**GEORGETOWN-SCOTT COUNTY PLANNING COMMISSION**

**AGENDA  
JUNE 10, 2021  
6:00 p.m.**

**CHERRY BLOSSOM, PHASE 9**  
**Staff Report to the Georgetown-Scott County Planning Commission**

**FILE NUMBER:** PSP-2021-10

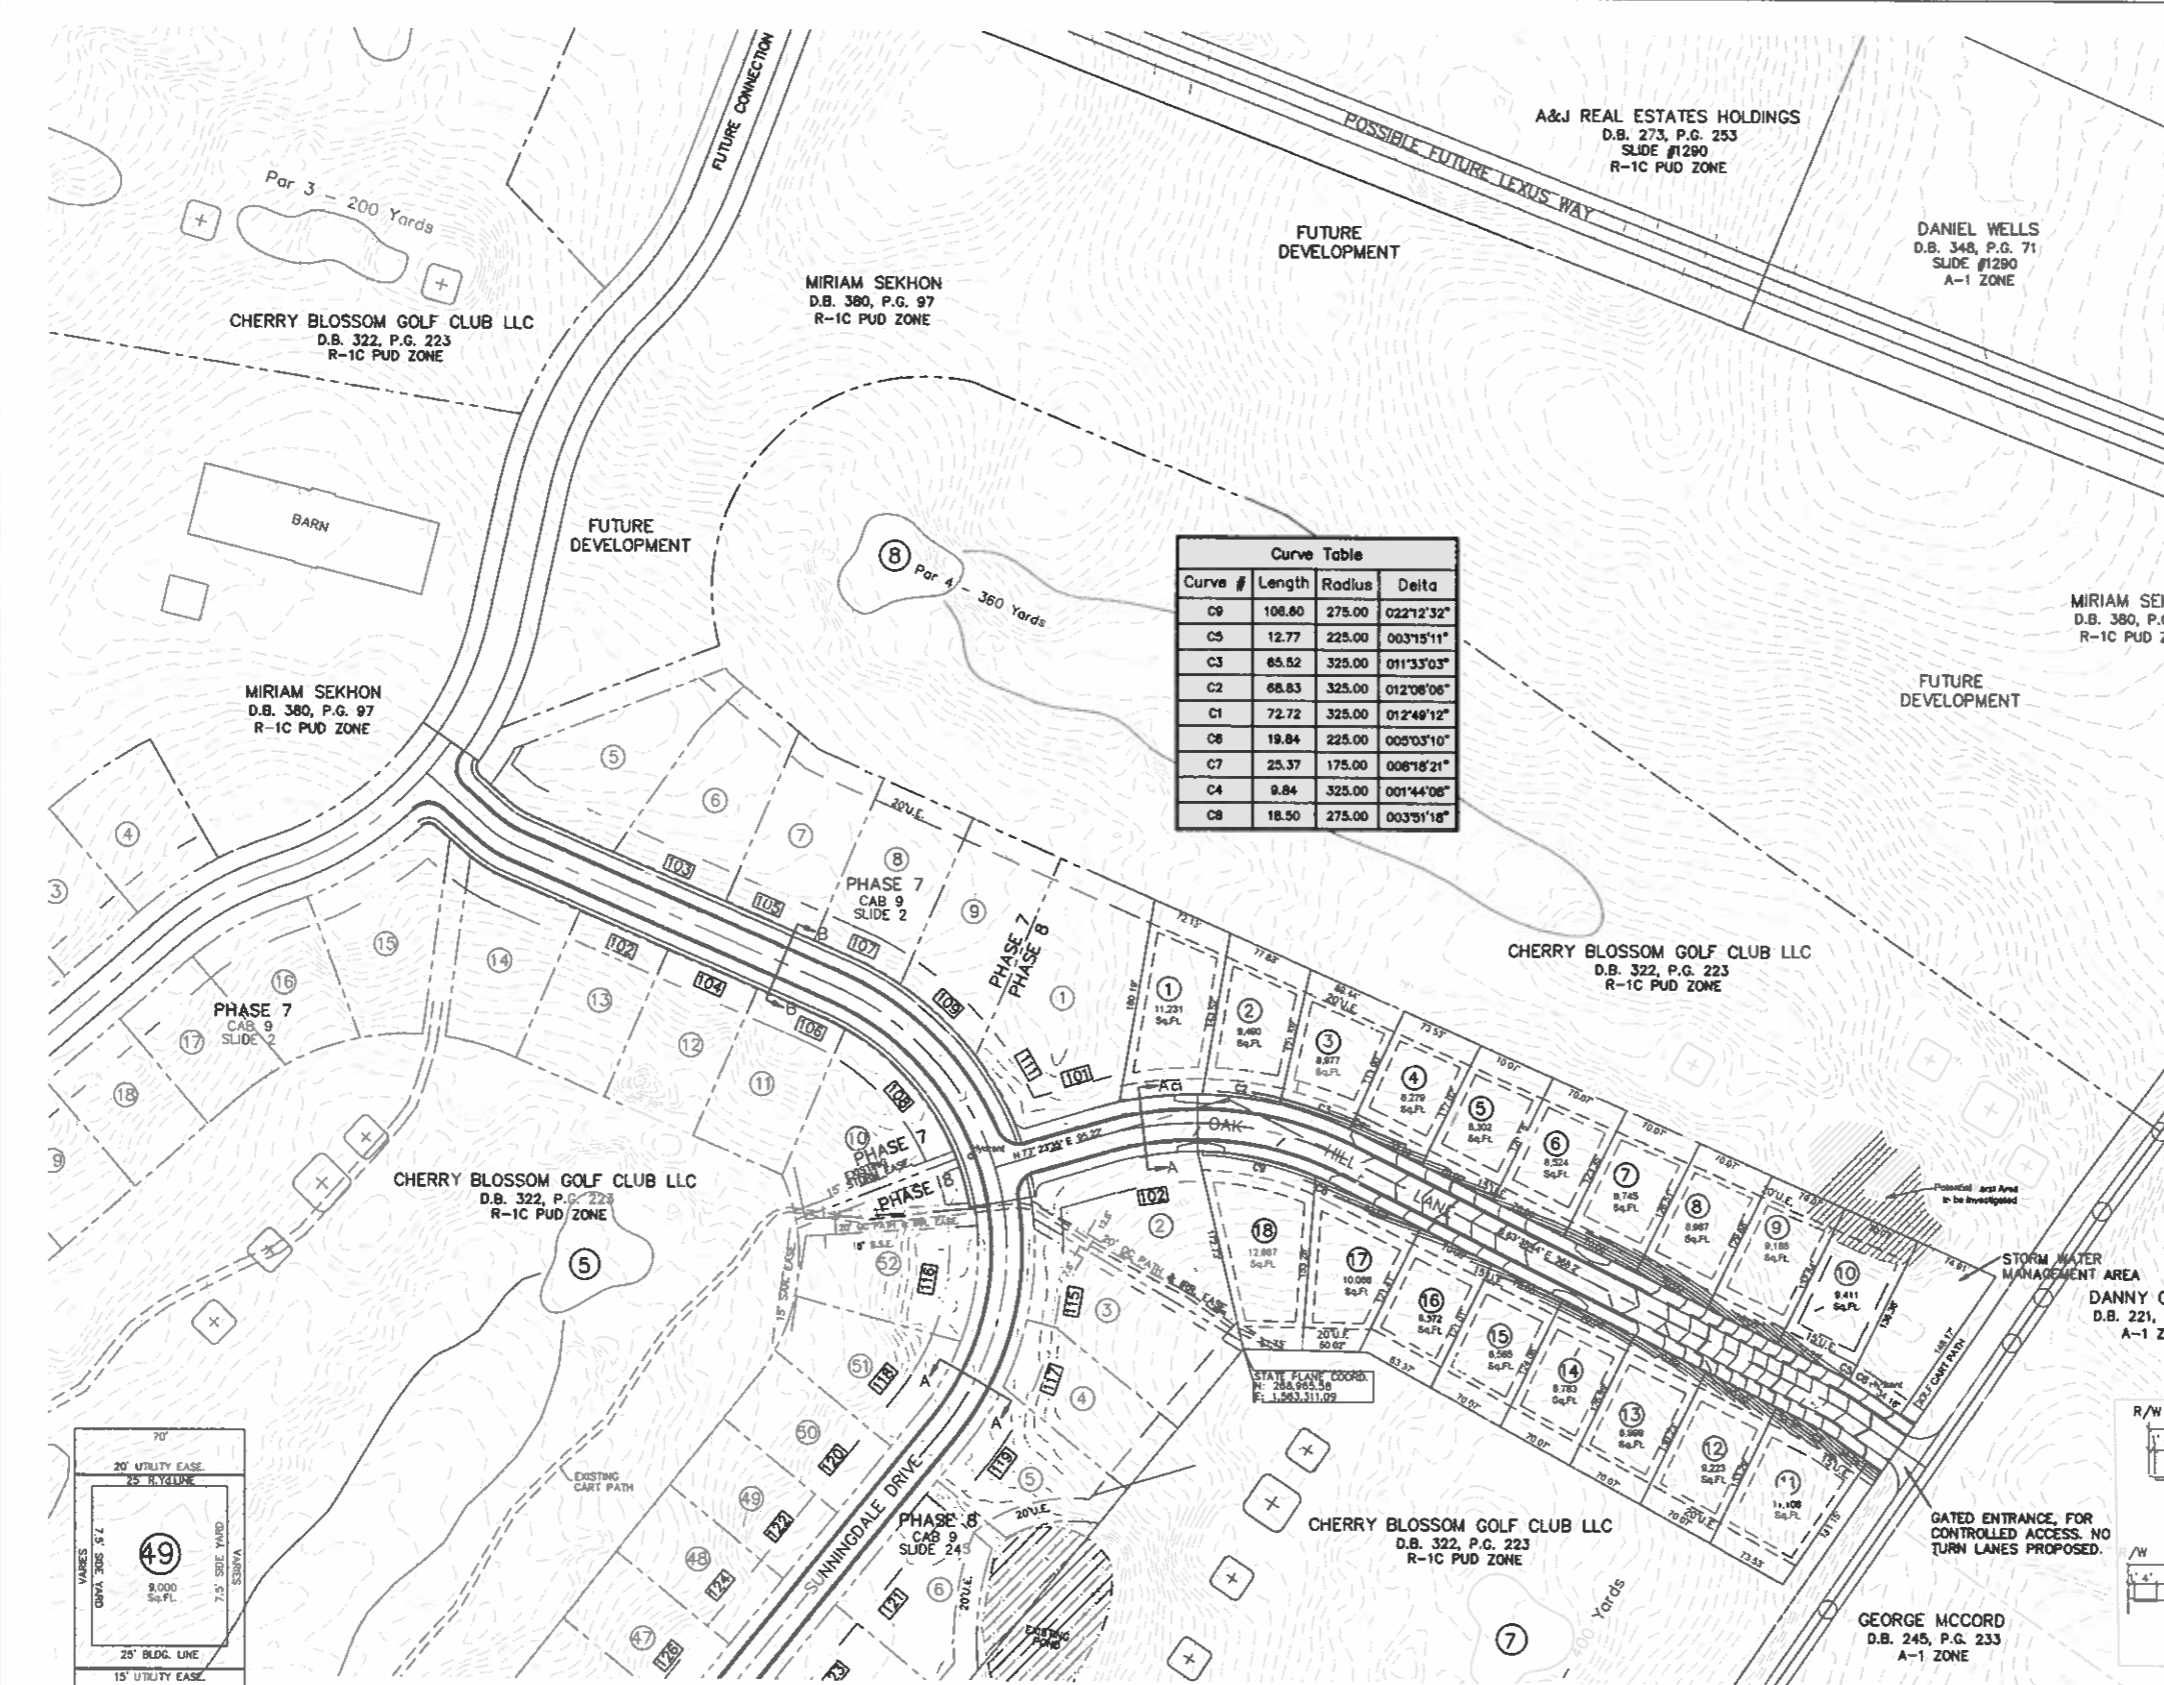
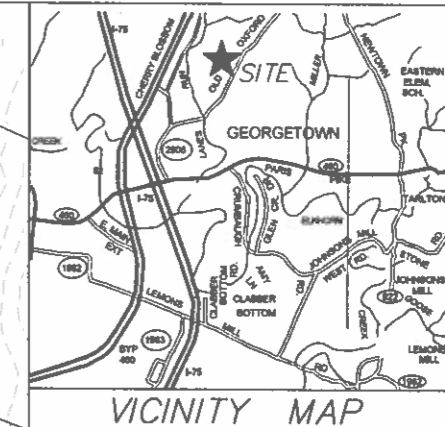
The layout, width, size of the proposed lots conforms with the underlying zoning and is consistent with previous approvals. A condition of approval of the previous phase (phase 8) also stated that "Any further approvals will require a connection to Old Oxford Road unless the applicant coordinates with the City and other property owners to provide these improvements collectively."

The applicant is proposing to make the connection to Old Oxford Road, but to install a gated controlled access. They have asked to waive the construction of turn lanes on Old Oxford due to their proposal to install a gate limiting use of the access to emergency vehicles, thru a manual or electronic pad locked gate of some sort.

The applicant has further proposed to provide a letter of credit for the widening of Old Oxford to the required 11' width from centerline, for the portions that front the developable areas (not golf course) between the bridge over Lanes Run Creek to the northeast corner of the development.

Staff is open to the option of a gate, but since this is proposed as a public street, the gate would need approval from the Planning Commission and the City at the time of dedication. Staff, however, would prefer an open access connection to improve traffic flow in the area.

Staff would also recommend the applicant provide a letter of credit for widening the entire length of Old Oxford along their frontage. The turn lanes are optional based on whether the access were to be controlled. A turnaround area would likely be needed inside the gate for utility trucks and other large non-emergency vehicles if the gate were to be fixed.

2. Applicant shall provide a gate accessible by emergency services at the entrance from Old Oxford Road. Planning Commission Engineer shall review the need for a turnaround at the gate depending on final location. Gate shall be approved by the City prior to dedication of street or this section of new street shall remain private. If the gate is not constructed, the developer shall submit a traffic analysis to determine the need for turn lanes at this entrance. The developer shall pay for any turn lanes determined to be required at the entrance on Old Oxford.

3. Applicant shall post letter of credit or cash surety for widening of Old Oxford to 11' from centerline along length of frontage.
4. Prior to any construction or grading, the applicant shall meet with the Planning Commission Engineer to review construction policies and establish inspection schedules.

CONCEPTUAL PLAN FOR ZONE CHANGE

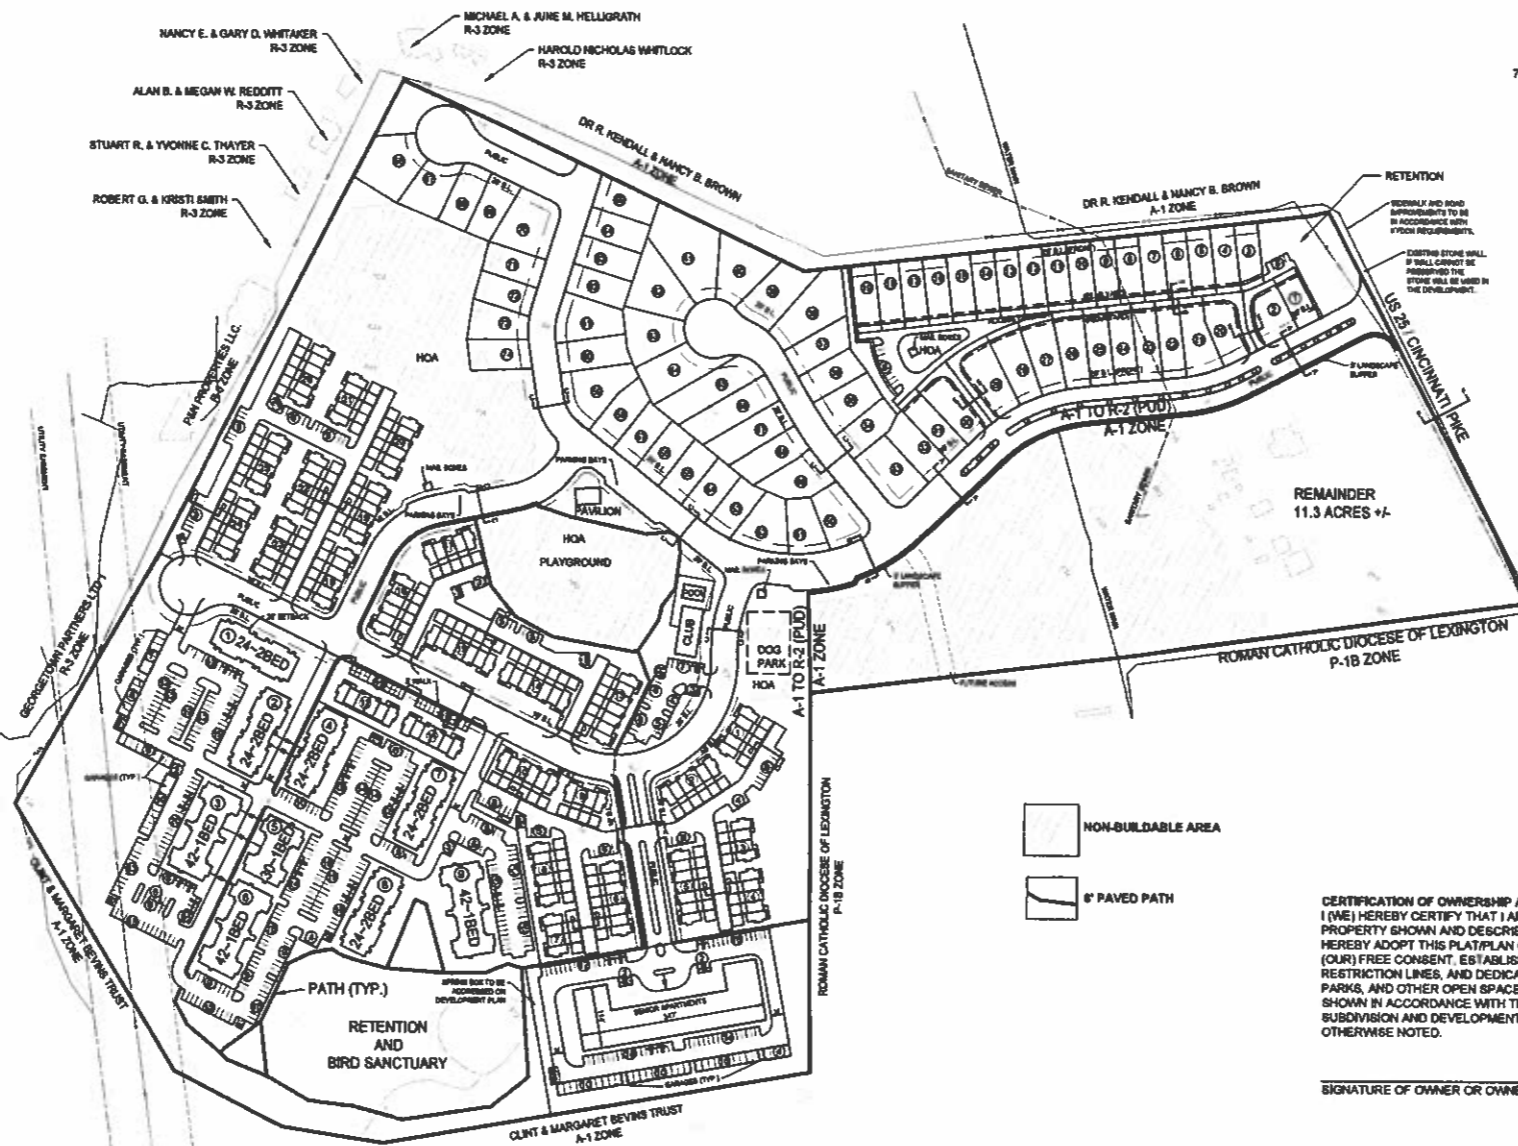
One major issue with the Concept Plan is that it lays out a 591 residential unit development with only a single connection proposed to an existing public street. The *Subdivision & Development Regulations* require single-family developments of 200 or more units and multi-family developments of 100 or more units to have at least two entrance intersections [Article X (P)(7)]. In mixed density developments the Planning Commission has previously required a second entrance intersection at 150 units or more, and staff recommends this same standard be applied to this development as well.

Staff's largest concern with the concept plan is vehicular access. The plan shows a connection to US 25, a road stub to the Brown Property to the north, and a "future access" to the Cardome Property to the south. Consideration should be given to additional connections to The Colony to the west and the Bevins Property to the south. Our neighborhoods and developments are enriched by additional transportation connections to the community. The Applicant's project at Amerson Orchard is a good example. That development has several connections to arterial roads as well as a connection to the adjoining neighborhood. These connections spread out the traffic flow and keep each individual entrance to a development from getting backed up to the point that it causes frustration. As the plan is currently drawn, staff has major concerns about how many vehicles would need to be utilizing a single entrance until an unknown date in the future when the stub to the Brown Property or a future access through Cardome connects to public roads that reach US 25.

1. Exceed maximum building height up to 38 ft. and 3 stories for apartments and senior apartments. *Staff does not recommend approval of this variance until the Preliminary Development Plan is submitted. Staff would prefer that the Planning Commission wait to review this waiver to see if the size and scale of some of the apartments could be reduced along some of the less intensively used neighboring properties.*
2. Reduce maximum lot area for single-family lots to 5,000 square feet. *Staff supports this variance. The Applicant is proposing to set aside more than 14 acres of open space for public use as part of the development, so it would be appropriate to allow for reduced lot sizes.*

3. Exceed the maximum units per building to 7 for townhomes, 42 for apartments, and 90 for senior apartments. *Staff supports granting a waiver to allow for 7 unit townhome buildings and a 90 unit senior apartment. At TRC, staff indicated that there were not any concerns with a 42-unit apartment building, but after further review of the concept plan staff wonders if it may be better to wait to decide on the number units allowed in these until the Preliminary Development Plan. As was described earlier, if there is a way to reduce the size and scale of some of the proposed buildings a 42-unit building may not be necessary.*

Staff also has some concerns about the size and scale of some of the buildings proposed near the agriculturally zoned property to the south. Staff is not ready to recommend approval of waivers related to the size and scale of the apartment buildings at this time. Without knowing the proposed grade of the land the buildings will be built from, it is hard to anticipate how the requested waivers/variances to size and scale will fit in with the surrounding area. The Applicant can still request these waivers with the Preliminary Development Plan that would be required for any multi-family development. At that time, they Applicant would normally have at least a preliminary grading plan for the site, which would make it easier to evaluate this issue.

1. All applicable requirements of the *Zoning Ordinance* and *Subdivision & Development Regulations*.
2. The Applicant shall annex the Project Site into the City of Georgetown.
3. The Applicant is responsible for providing a legal description of the Project Site to the City of Georgetown as part of the Zoning Map Amendment process.
4. The Planning Commission shall not approve more than 150 dwelling units to be constructed until the development has at least 2 public road connections to an arterial road.
5. The Applicant shall construct turn lanes, as described in the Traffic Impact Study, as part of the first Development Plan/Subdivision Plat for the Project Site.

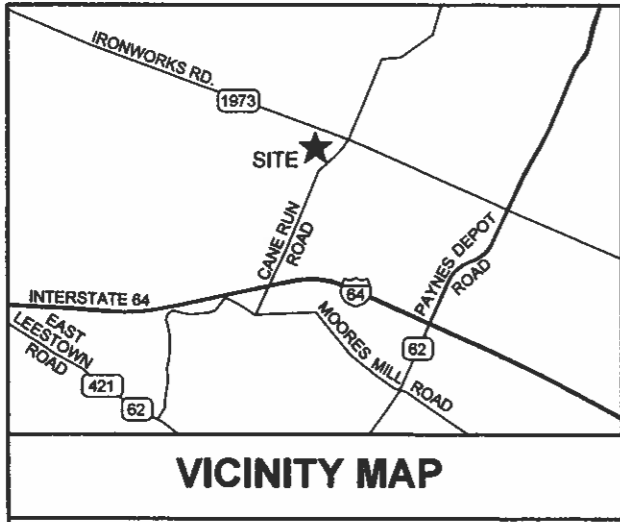
The proposed plat shows the appropriate the setbacks, and the proposed lot meets the lot size and width requirements.

Access to Tract 2 is proposed from Ironworks Road (KY-1973), and the residual tract has an existing driveway from Ironworks Road. The plat also proposes adjusting the entrances for two 5-acre lots the Applicant had previously created with the plat recorded at Cabinet 7, Slide 43. Both previously created lots are still owned by the Applicant. The new entrance proposed by this plat, and the adjusted entrances on the adjoining 5-acre lots will all require review and approval by KYTC.

1. All applicable requirements of the *Zoning Ordinance* and *Subdivision & Development Regulations*.
2. Any revisions or amendments to the approved Preliminary Subdivision Plat shall be reviewed and approved by the Planning Commission staff (minor) or by the Planning Commission (major).
3. Prior to (as part of) the Final Subdivision Plat approval, the applicant shall provide the Planning Commission staff (GIS division) with a digital copy of the approved plat.
4. This Preliminary Subdivision Plat approval is valid for two years, subject to the requirements of Article 306 section A of the *Subdivision and Development Regulations*.
5. The Applicant shall provide staff with copies of the permits issued by KYTC for the entrances created/adjusted by this plat.
6. The purpose statement for the plat shall be adjusted to include mention of the adjusted entrances for the adjoining lots.

**POPP PROPERTY  
PRELIMINARY SUBDIVISION PLAT**

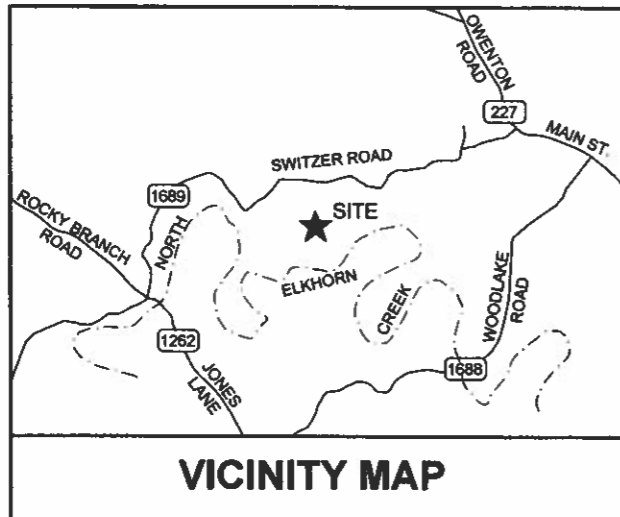
Staff will need the Final Subdivision Plat(s) to verify that the proposed subdivision lines do not cause existing structures to violate the setback requirements.

Tracts 1-4 will also use an existing entrance. This access point involves the construction of a roadway and turnaround that will meet county road standards. An access easement will come from the turnaround to provide access to Tracts 3 & 4. A separate access easement will come off the turnaround to provide access to Tracts 1 & 2. For clarification, staff will ask that these access easements be given labels (such as 'Access Easement A') on the Final Subdivision Plat(s) so that it can be clear for future owners which easements are usable by which tracts and how maintenance will be handled. This roadway & turnaround will need to be constructed prior to the platting of Tracts 1, 2, 3, or 4.

There is a label for an access easement on Tract 2, that does not seem to lead to any other tracts. This may be an error.

The plat also is proposed to create 'creek access' easements. Staff will also require these easements to be defined on the Final Subdivision Plat(s) as far as which lots are being served by each easement, how they will be maintained, and any other pertinent information.

6. The Applicant shall provide staff with copies of the permits issued by KYTC for the entrances created/adjusted by this plat.
7. The purpose statement for the plat shall be adjusted to describe the changes made to the existing property by this plat including consolidation, subdivision, and the creation of access easements.

**VILLAGE AT LANES RUN, PHASE 3, SECTION 2  
AMENDED MASTER PLAN AND PRELIMINARY SUBDIVISION PLAT**

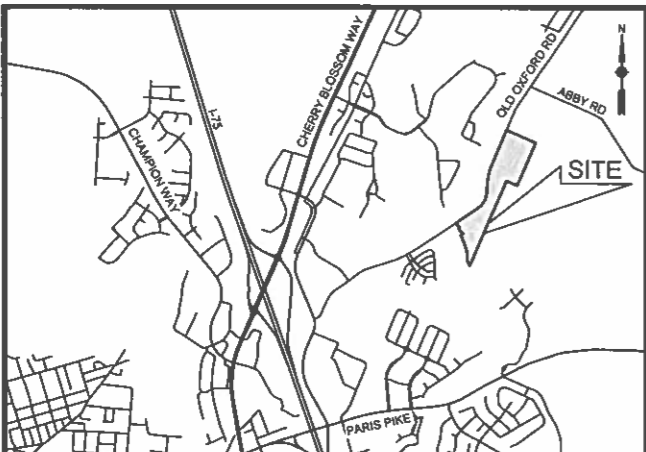
The applicant is proposing a new second entrance to Old Oxford Road east of Lanes Run Creek. The applicant will be responsible for completing all improvements at the new entrance including turn lanes and widening of Old Oxford Road to 11' from centerline along the frontage of the lots.

Staff recommends **Denial** of the Amended Preliminary Subdivision Plat for Phase 3, Section 2. The proposed amendments particularly the change in the open space arrangement and the reduction in the minimum lot widths throughout the phase and the increase in the number of lots due to the above proposed changes are not supportable in terms of the original PUD approval.

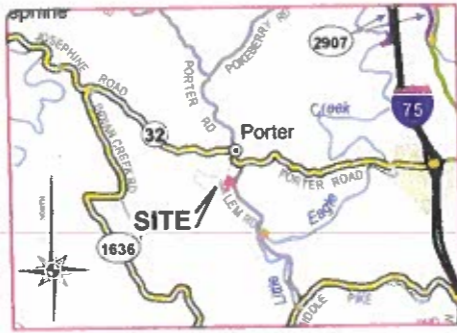
The Planning Commission Engineer visited the Project Site and has some concerns about the safety of the shown entrance to the proposed 5-acre lot. It may be necessary for tree removal or other improvements to make this a safe access to the property. The Applicant should work with the County Road Supervisor and Planning Commission Engineer to determine what improvements may be necessary.
